Project	IEEE 802.16 Broadband Wireless Access Working Group < http://ieee802.org/16 >	
Title	Amendments to the Multi-hop Relay System Evaluation Methodology Document {Harmonized}	
Date Submitted	2006-11-16	
Source(s)	<p>Gamini Senarath, Mark Naden, Dean Kitchener, G.Q. Wang, Wen Tong, Peiyong Zhu Hang Zhang, David Steer, Derek Yu, Nortel 3500 Carling Avenue Ottawa, Ontario K2H 8E9</p> <p>Andy Molisch, 201 Broadway, Cambridge, MA, 02139, USA</p> <p>Yon Sun, Dharma Bageet, Toshiba, 32, Queen Square, Bristol, BS1, UK</p> <p>I-kang Fu, National Chiao-Tung University, Industrial Technology Research Institute, ED922, 1001 Ta hsueh Road, Hsinchu, Taiwan 300, ROC</p> <p>Peter Wang, Nokia,, 6000, Conenction Drive, Irving, Texas</p> <p>Roger Peterson, Motorola Inc., 10105 Pacific Heights Blvd, Suite 250, San Diego, CA 92121, USA</p>	<p>Voice: 1-613-763-1315 [mailto:wentong@nortel.com]</p> <p>Andreas.Molisch@ieee.org</p> <p>sun@toshiba-trel.com</p> <p>IKFu@itri.org.tw</p> <p>peter.wang@nokia.com</p> <p>David..t.chen@motorola.com</p>

Re:	Call for Technical Proposals regarding IEEE Project P802.16j (IEEE 802.16j-06/027)

Amendments to the Multi-hop Relay System Evaluation Methodology Document

Figure 3, BS-RS NLOS (ART to BRT)

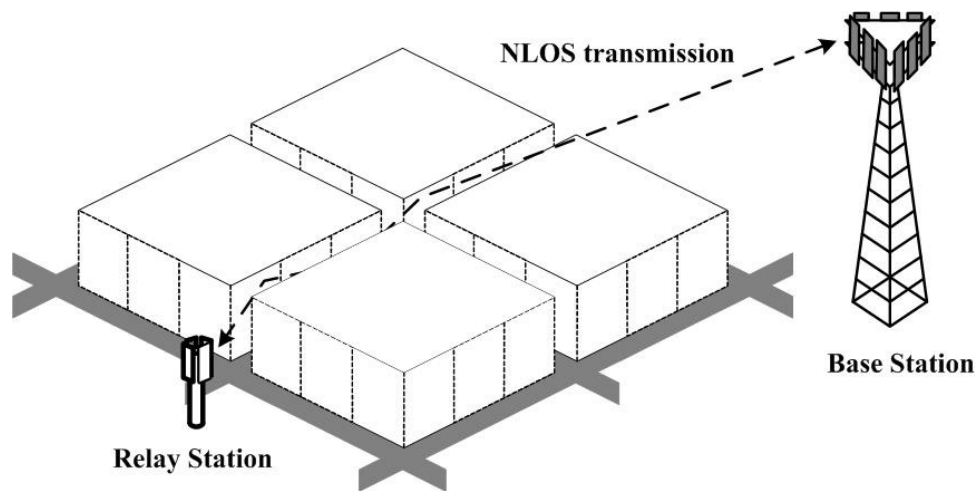
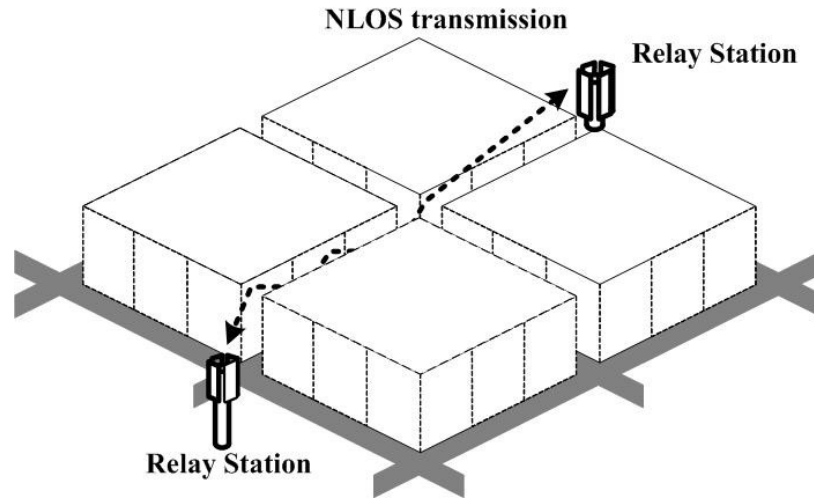
- c) The type E model does not have adequate parameters to be used for the simulations. In order to have alignment across different simulations we propose to have some parameters specified.

Proposed Text Change: Proposed Text Change: The Text marked in Blue color included in Section 2.1.2.3 below should be inserted into Type E model description in the 802.16j-06/013r1 document.

Parameter values to be used for this model are provided below. The use of these values is not mandatory.

Building spacing, $b = 60\text{m}$ (this is the spacing between building centers)
Street width, $w = 12\text{m}$ (this is the spacing between building faces)
Street orientation = 90 degrees
Average rooftop height, $h_{\text{roof}} = 25\text{m}$
